Item Name: Crosstube Aft

DART AEROSPACE LTD	Work Order:	99662
Description: Crosstube High Aft (412)	Part Number:	D412-664-203
Inspection Dwg: D412-664-243	Rev: E	Page 1 of 1

DRAWING NO. D412-664-243	TITLE CROSSTUBE ASS'Y (412 HI AFT)	REV. E	DART AEROSPACE LTD ENGINEERING ORDER		D.E.O. NO. D412-664-243-E-2	SHEET NO. SHEET 1 OF 1	SCALE NTS
DRAWN JP	CHECKED AS	MFG. APPR. E	APPROVED WP		DE APPR. H		
DATE 11.09.07	DATE 11.09.19	DATE 11.09.19	DATE 11.09.19		DATE 11.09.19

DRAWING NO. D412-664-243	TITLE CROSSTUBE ASSEMBLY (412 HI AFT)	REV. E	DART AEROSPACE LTD ENGINEERING ORDER		D.E.O. NO. D412-664-243-E-4	SHEET NO. SHEET 1 OF 3	SCALE NTS
DRAWN MP	CHECKED A	MFG. APPR. A	APPROVED MP		DE APPR. MP		
DATE 12.08.21	DATE 12.08.30	DATE 12.08.30	DATE 12/8/30		DATE 12.08.30

**D412-664-243
ASSEMBLY DETAIL**

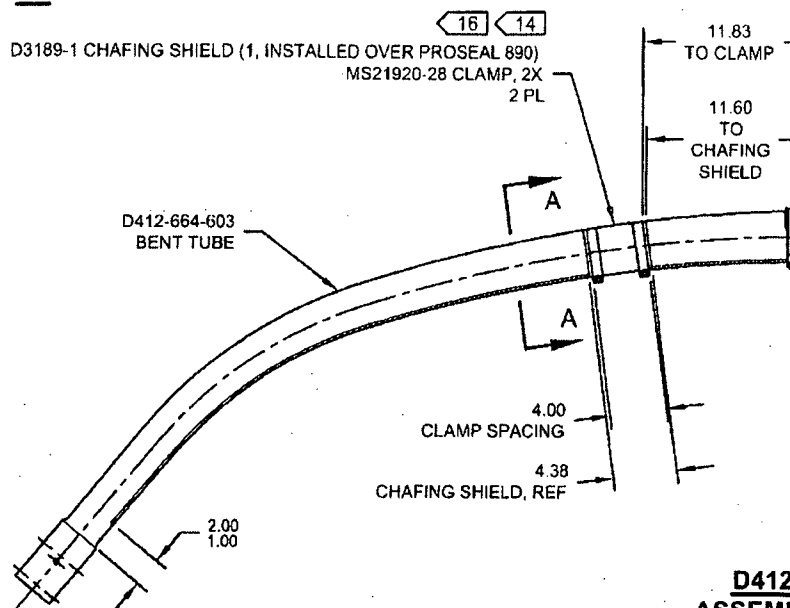
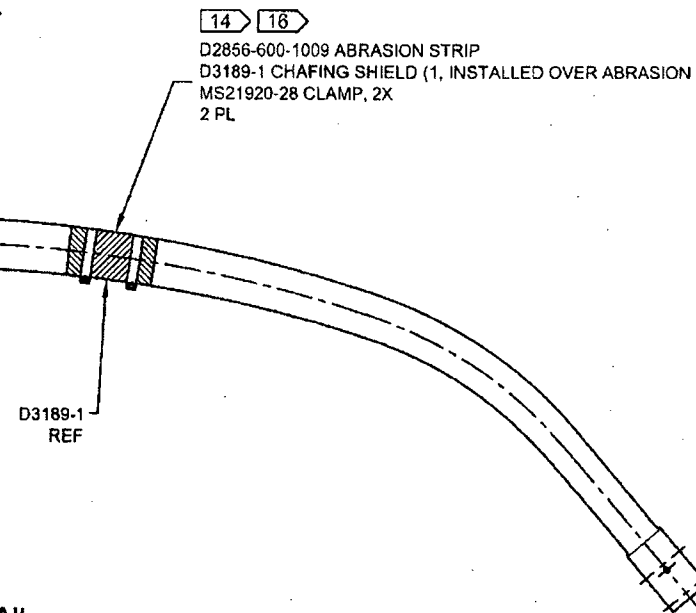
PURPOSE:

REMOVED ABRASION STRIP IN FAVOR OF A THIN LAYER OF PROSEAL 890. UPDATE INSTALLATION OF CHAFING SHIELDS AND REDUCE TORQUE TO 40-50 IN-LBS. THIS ENGINEERING ORDER SUPERCEDES DEO D412-664-243-E-1.

D3189-1 CHAFING SHIELD (1, INSTALLED OVER PROSEAL 890)
MS21920-28 CLAMP, 2X
2 PL

14 **16**
D2856-600-1009 ABRASION STRIP
D3189-1 CHAFING SHIELD (1, INSTALLED OVER ABRASION STRIP)
MS21920-28 CLAMP, 2X
2 PL
